UNITED STATES PATENT AND TRADEMARK OFFICE

APPLICATION NO.	FILING DATE	FIRST NAMED INVENTOR	ATTORNEY DOCKET NO.	CONFIRMATION NO.
10/527,490	11/17/2005	Dominique Petit	05-240	3577
34704	7590	08/14/2006		
BACHMAN & LAPOINTE, P.C. 900 CHAPEL STREET SUITE 1201 NEW HAVEN, CT 06510			EXAMINER WOODALL, NICHOLAS W	
			ART UNIT 3733	PAPER NUMBER

Office Action Summary

DETAILED ACTION

Figure 1

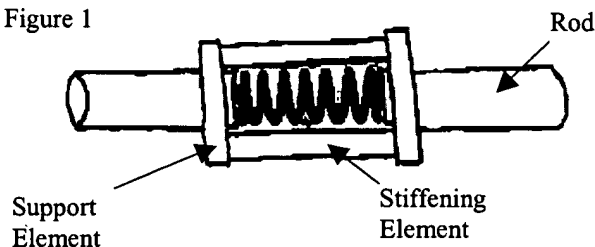
10. Claims 11 and 16-20 are rejected under 35 U.S.C. 103(a) as being unpatentable over Paul (U.S. Patent 6,986,771).

Regarding claims 11 and 16-19, Paul discloses the invention, as shown in figure 1 below, as claimed except for the support being made from a polymeric material. It would have been obvious to one having ordinary skill in the art at the time the invention was made manufacture the support of Paul from a polymeric material, since it has been held to be within the general skill of a worker in the art to select a known material on the basis of its suitability for the intended use as a matter of obvious design choice. In re Leshin, 125 USPQ 416.

Figure 2

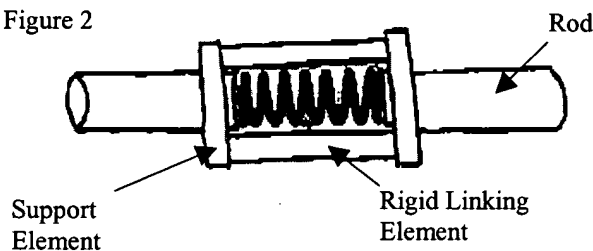
11. Claims 11, 16, 18 and 20 are rejected under 35 U.S.C. 103(a) as being unpatentable over Paul (U.S. Patent 6,986,771) as a different interpretation then discussed above.

Regarding claims 11, 16, 18 and 20, Paul discloses the invention, as shown in figure 2 below, as claimed except for the support being made from a polymeric material. It would have been obvious to one having ordinary skill in the art at the time the invention was made manufacture the support of Paul from a polymeric material, since it has been held to be within the general skill of a worker in the art to select a known material on the basis of its suitability for the intended use as a matter of obvious design choice. In re Leshin, 125 USPQ 416.
